Attachment G: Species Consultation

- ODNR Survey Effort Letter 4/25/18
- ODNR Survey Effort Letter 8/17/17
- ODNR Review Letter 11/21/12
- USFWS Review Letter 10/24/12
- ODNR Survey Effort Letter 2/25/09
- USFWS Project Review Letter 8/3/08
- IPaC Resource List - December 2018

Seneca Wind Project (April 2018)

Survey effort map with the revised boundary for the proposed Seneca project (April 2018).

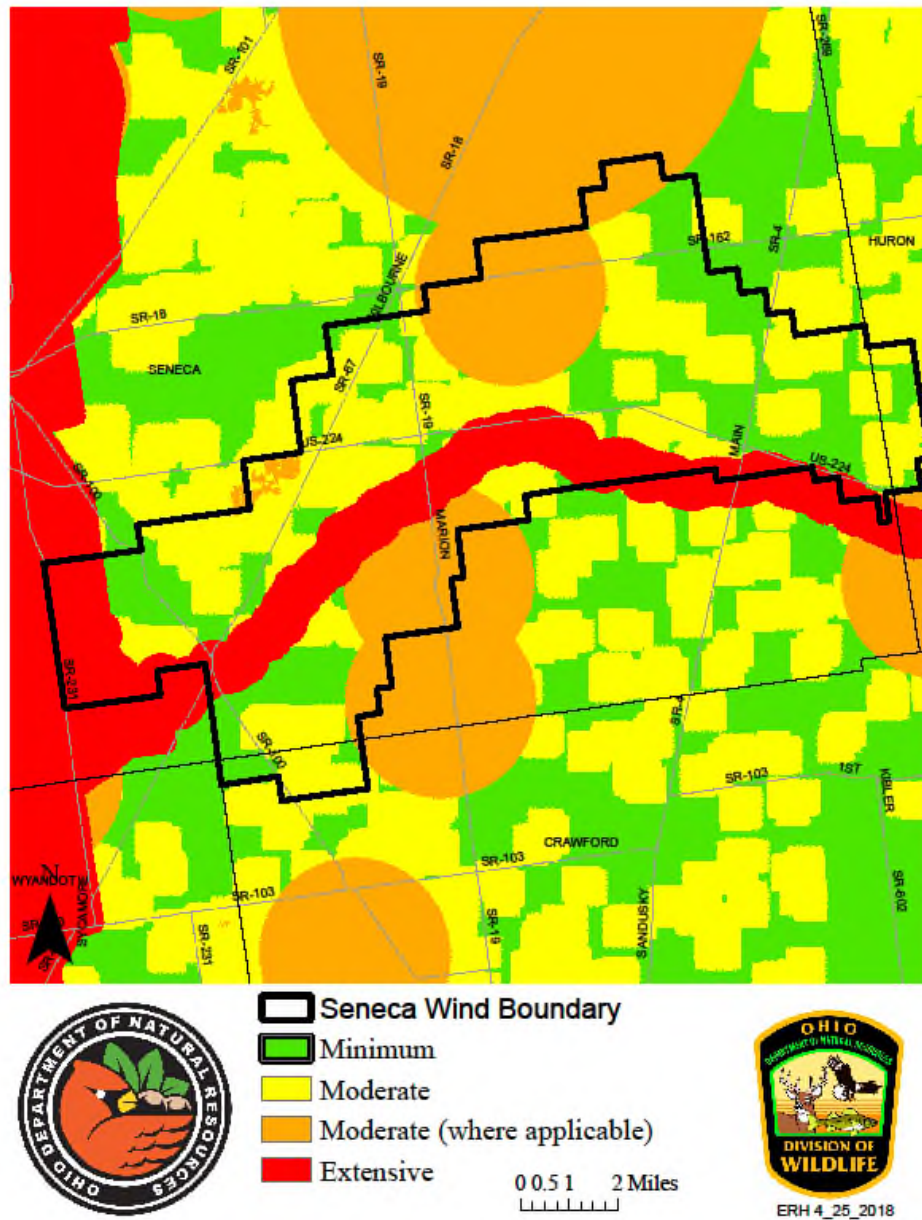
Based upon the revised project boundary map received April 2018, the Ohio Department of Natural Resources Division of Wildlife (DOW) has prepared initial survey recommendations for the proposed Seneca project located in Seneca, Huron, and Crawford counties regarding wildlife species.

Currently the project falls within regions of the state that DOW has identified as needing extensive monitoring efforts based on GIS analysis of the site. However, previous DOW recommendations have determined the habitat is not what DOW considers high-quality stopover habitat for migrating passerines and waterfowl. Therefore, the proposed facility was classified as a "moderate" site under the current protocols. If the developer decides to amend the current boundaries, the DOW will revise our survey recommendations.

The attached table summarizes the types and level of survey effort recommended by the DOW. Results from these studies will help assess the potential impact the turbines may pose and will influence our recommendations to the Ohio Power Siting Board.

Survey effort map with the revised boundary for the proposed Seneca project (August 2017).

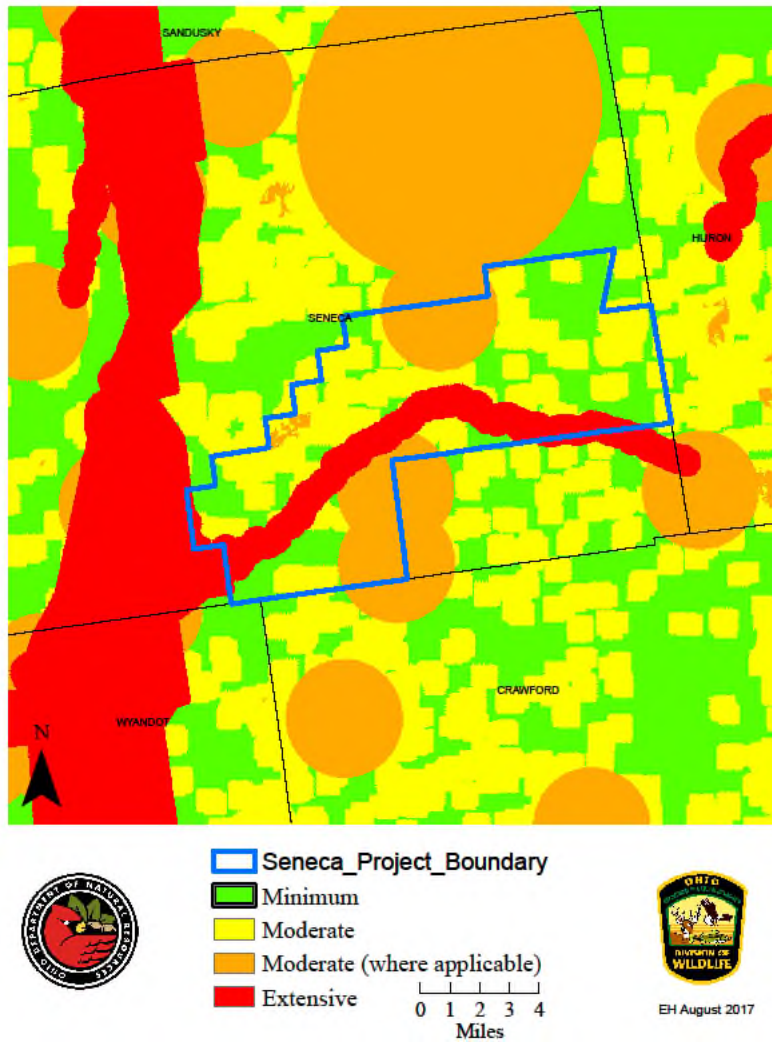
Based upon the revised project boundary map received July 2017, the Ohio Department of Natural Resources Division of Wildlife (DOW) has prepared initial survey recommendations for the proposed Seneca project located in Seneca County regarding wildlife species.

Currently the project falls within regions of the state that DOW has identified as needing extensive monitoring efforts based on GIS analysis of the site. However, previous DOW recommendations have determined the habitat is not what DOW considers high-quality stopover habitat for migrating passerines and waterfowl. Therefore, the proposed facility was classified as a "moderate" site under the current protocols. If the developer decides to amend the current boundaries, the DOW will revise our survey recommendations.

The attached table summarizes the types and level of survey effort recommended by the DOW. Results from these studies will help assess the potential impact the turbines may pose and will influence our recommendations to the Ohio Power Siting Board.
